## PLANNING COMMISSION STAFF REPORT

DATE: December 9, 2015

SUBJECT: A MAJOR ARCHITECTURAL APPLICATION (MAJ) BY DENLAR, LLC, OWNER, FOR DEVELOPMENT OF A NEW HILLSIDE SINGLE FAMILY RESIDENCE LOCATED AT 2110 LEONARD ROAD; ZONE R-1-B. (CASE 3.3817 MAJ). (KL)

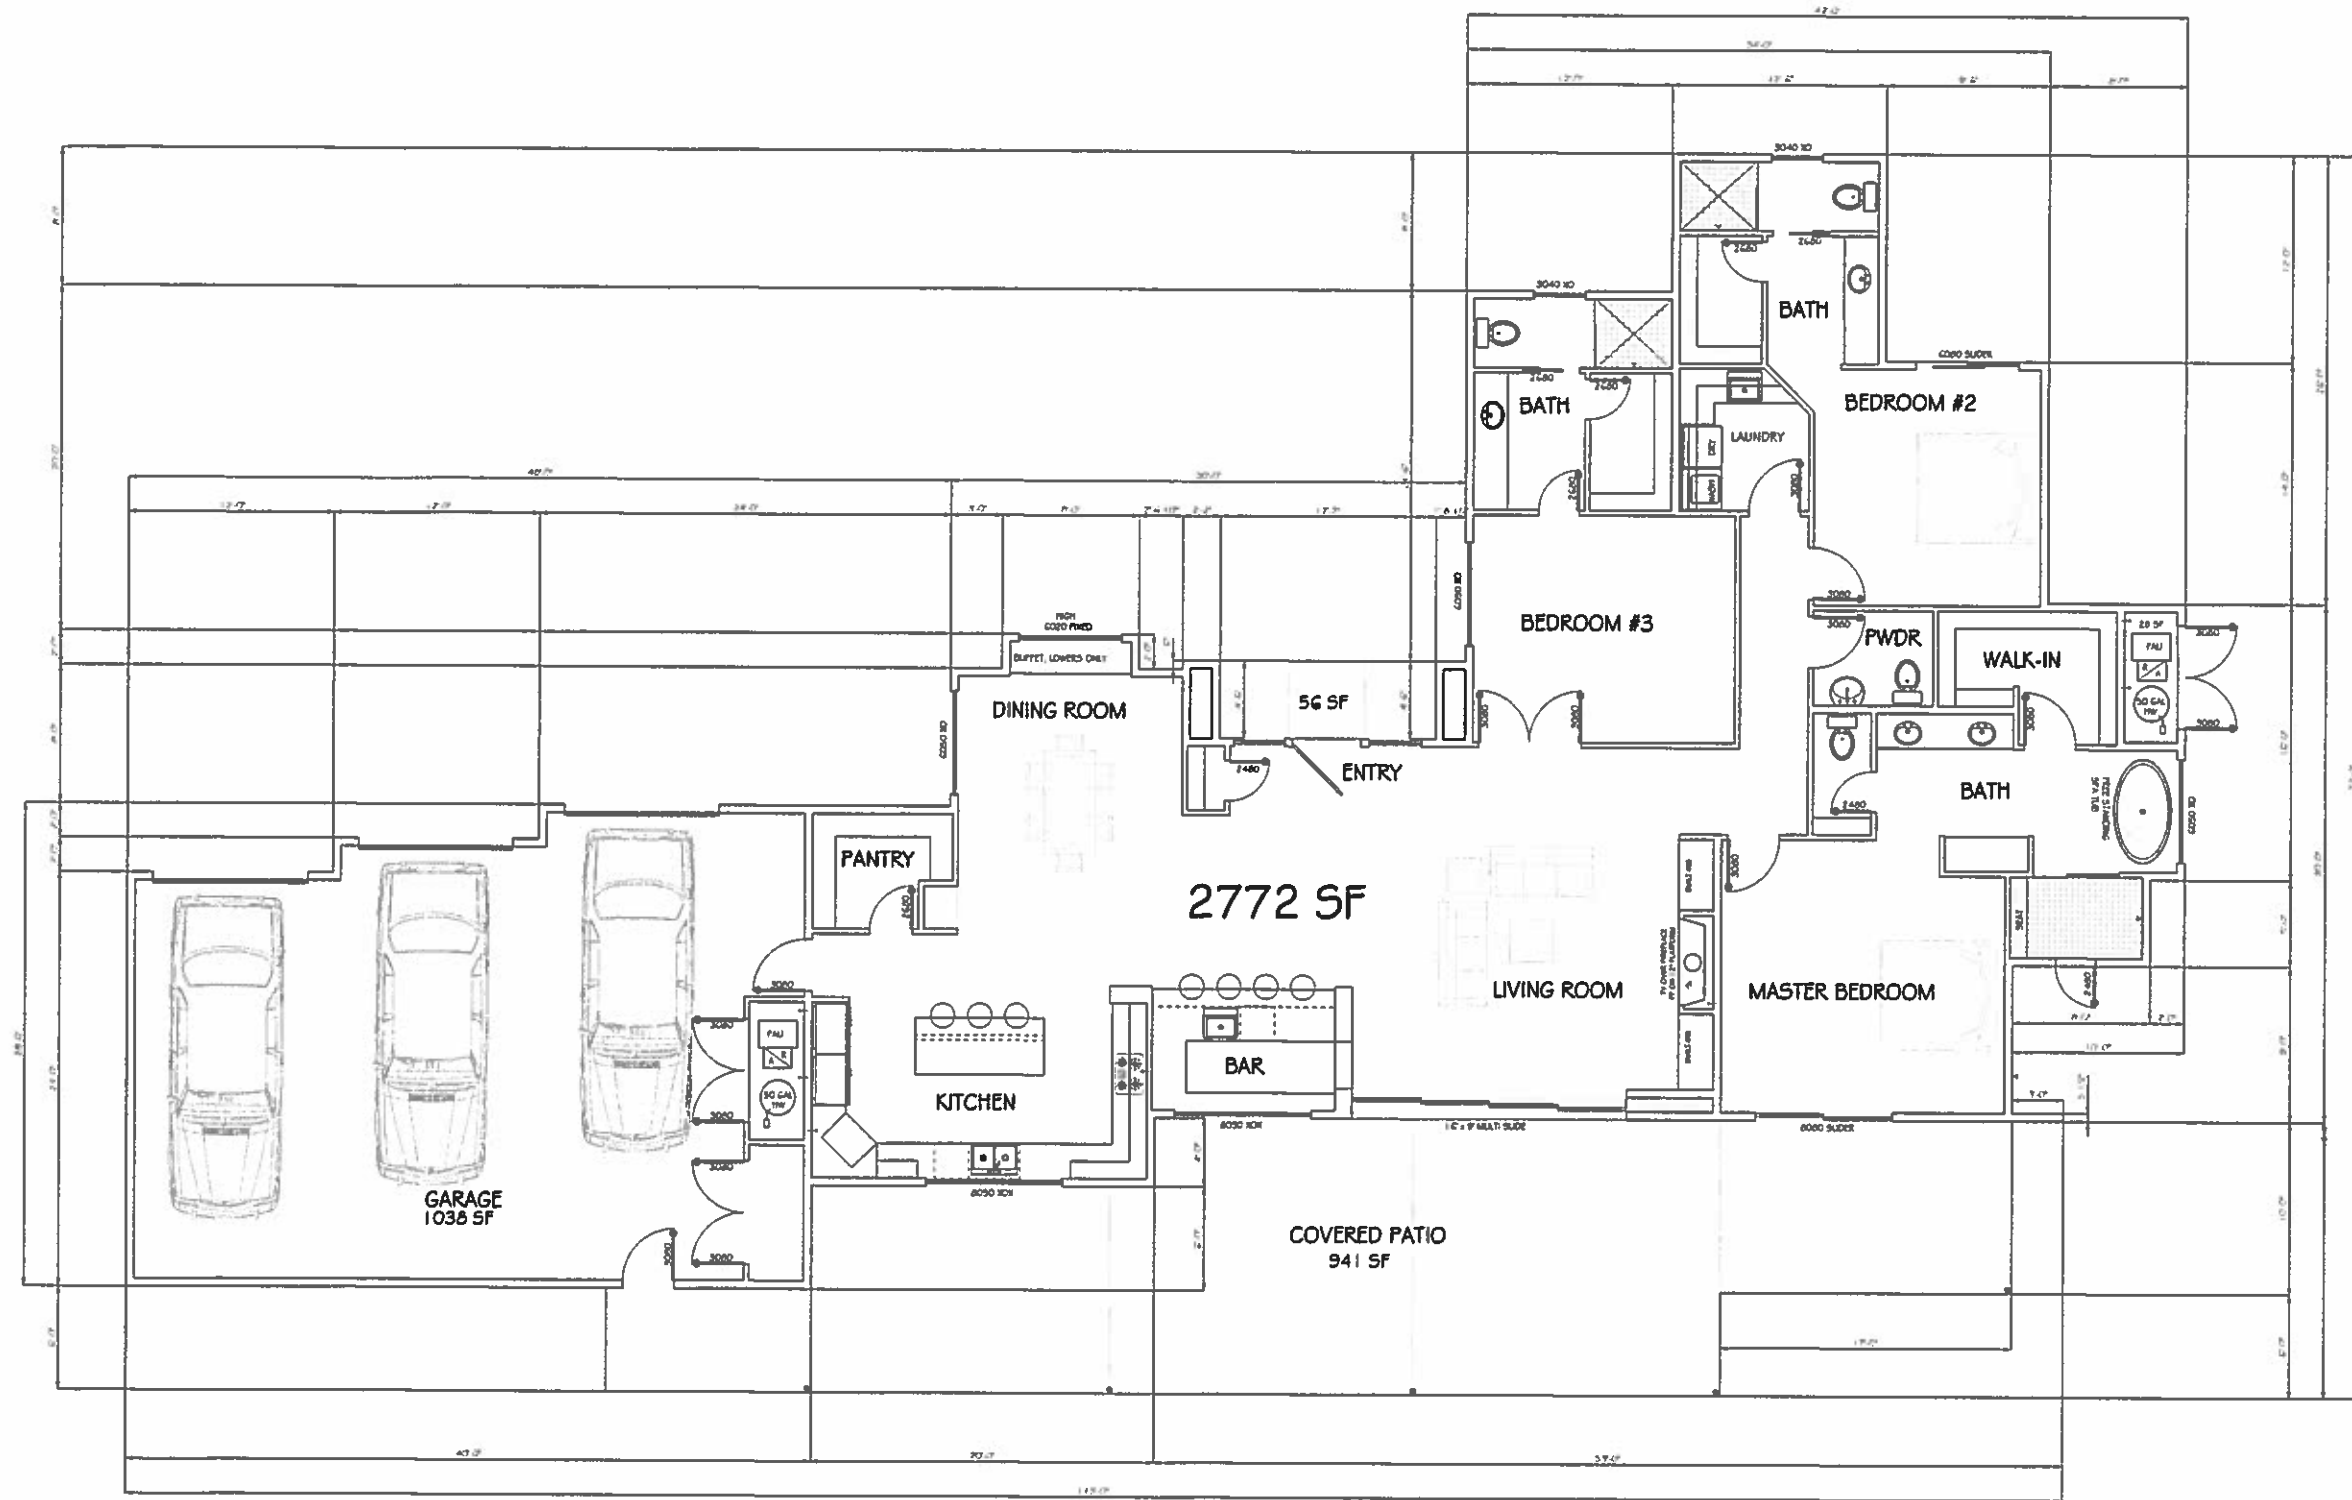
Member Song verified the height of the window awnings and construction details; and verified the recess pattern of garage doors. She expressed concern with the expanse of concrete at the driveway.

Chair Fredricks questioned if there is adequate soil on both sides of driveway for additional plantings. He asked if canopy trees could be used in place of palm trees at the front of the house and suggested a more drought-tolerant species.

Member Hirschbein said the driveway is overpowering and could use inert material between the panels of concrete; and more "native" trees in front of the house.

Member Secoy-Jensen commented that driveway needs to be softened.

- Concern with the use of pepper trees; and suggested replacing with Palo Verde or Mesquite trees;
- Increase size of plant materials;
- More screening around the driveway;
- Revise landscape plan;

1. Landscape plan including driveway design to return for review by the AAC.

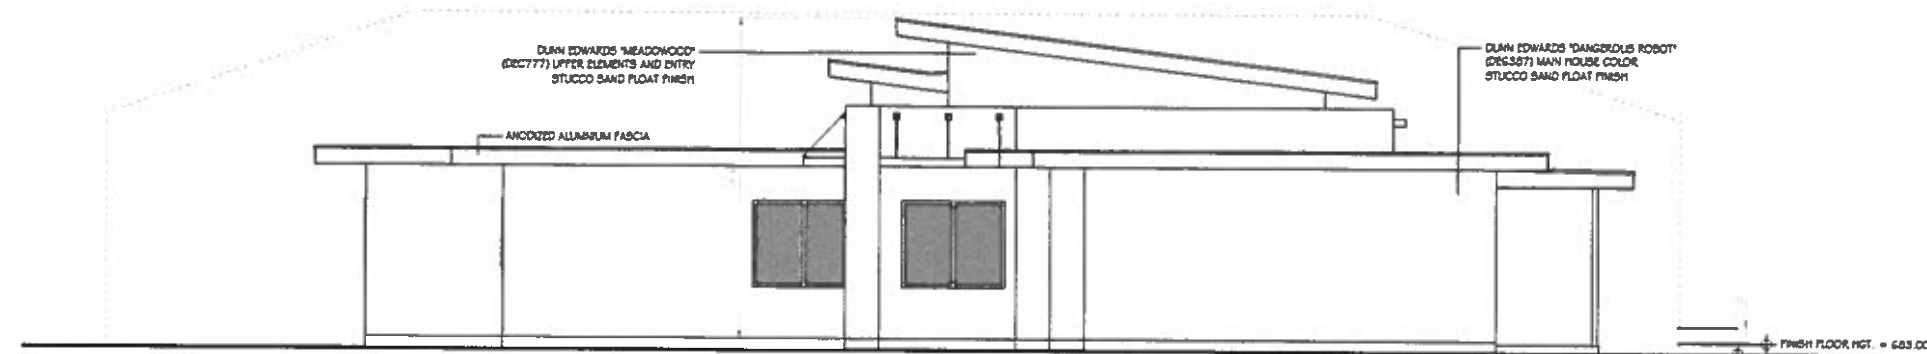
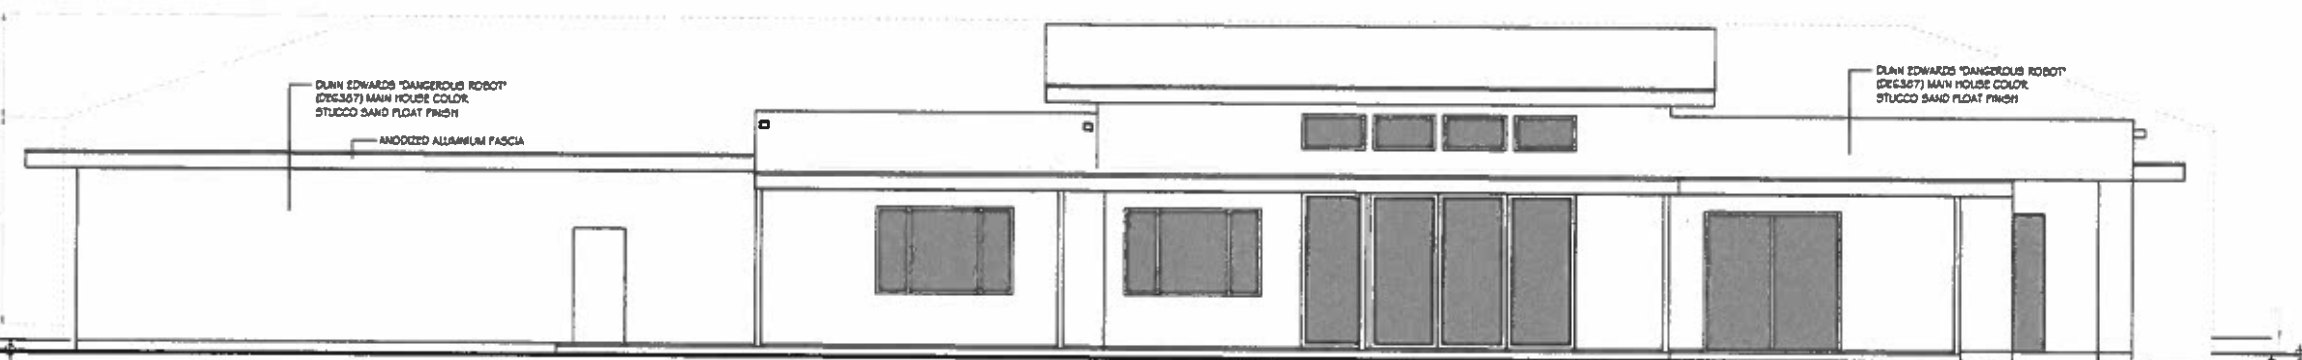
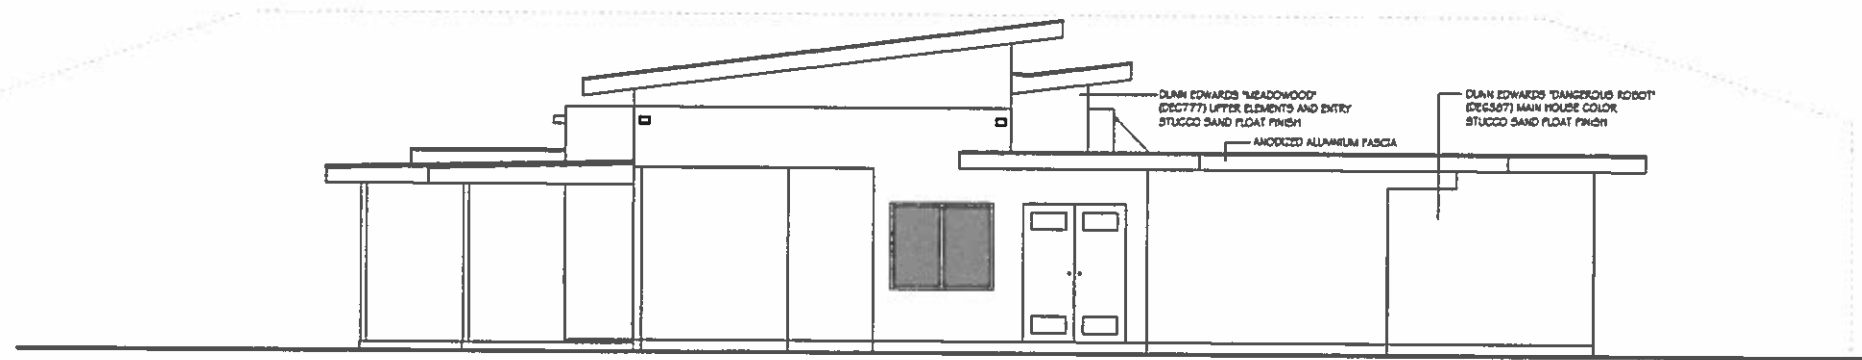
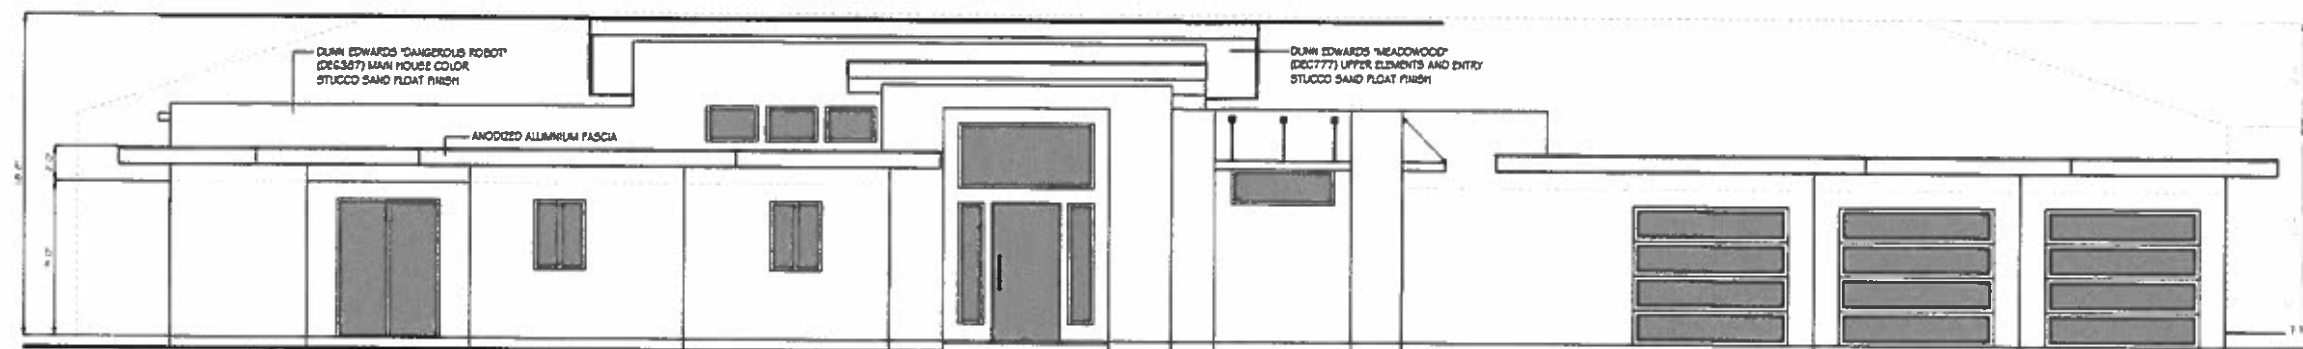
Member Fauber agreed with the driveway comments and suggested removing the brace element from awning.

Member Song expressed concern with the roof overhangs relative to the awnings and windows; placement of windows relative to façade width (centered vs. asymmetrical).

The AAC also suggested that the applicant consider removing the angle brace and drop height of the awnings (not to align with roof).
